10/830,120

Jung-hyun Lee

Office Action Summary

DETAILED ACTION

Fig. 2

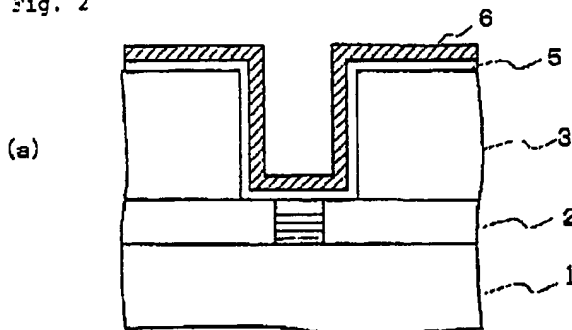
Regarding claim 1, Aoki et al. discloses a stack-type capacitor comprising:

a lower electrode; (Aoki et al., Fig. 2 ref #'s 5&6)

a dielectric layer formed on the lower electrode; (Aoki et al., Fig. 2 ref # 7)

wherein the lower electrode includes:

a first metal layer having a cylindrical shape; and (Aoki et al., Fig. 2 ref # 5)

a second metal layer filled in the first metal layer. (Aoki et al., Fig. 2 ref # 6)

a lower electrode; (Aoki et al., Fig. 2 ref #'s 5&6)

a dielectric layer formed on the lower electrode; (Aoki et al, Fig. 2 ref # 7)
and an upper electrode formed on the dielectric layer, (Aoki et al, Fig. 3 ref # 8)
wherein the lower electrode includes:
a first metal layer having a cylindrical shape; and (Aoki et al, Fig. 2 ref # 5)
a second metal layer filled in the first metal layer. (Aoki et al, Fig. 2 ref # 6)

Fig. 3

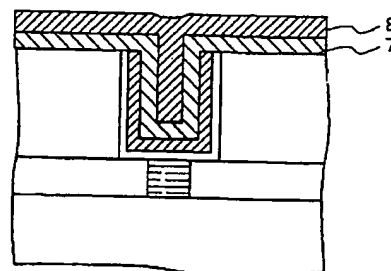
and an upper electrode formed on the dielectric layer, (Aoki et al., Fig. 3 ref # 8)
